**1 Products affected**

**2 Type of change**

Change Notice						PCN UMx 250 - Added Meti approval	
owner	creation date	release date	released by	change order	rev	page	D10-069-916
bianchro	04.01.2023	04.01.2023	schulejo	2025268	B	1 of 2

Current product approval	New product approval
No PSE - JET	PSE - JET
Current product appearance	New product appearance

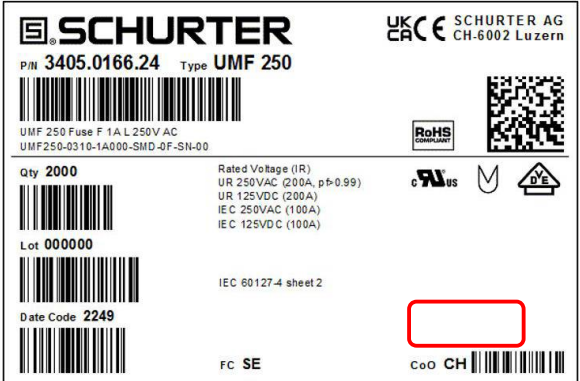
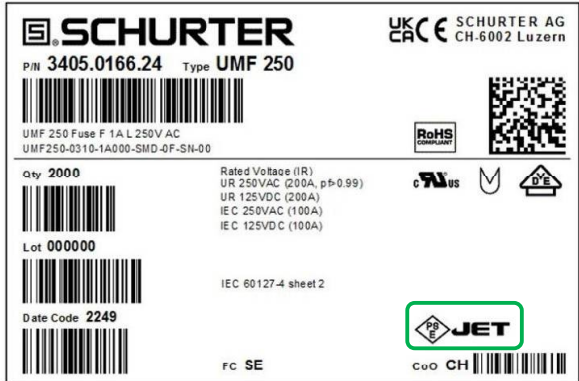
- Change of approval markings and packaging labels adding PSE - JET. This change has no effect on the validity of the approval certificates.
- The Meti Approval from the Japan Electrical Safety & Environment technology Laboratories (JET) with number JET 2245-31007-2006 applies for the whole UMx 250 family. The PSE-JET logo appears on the fuses and packaging labels.
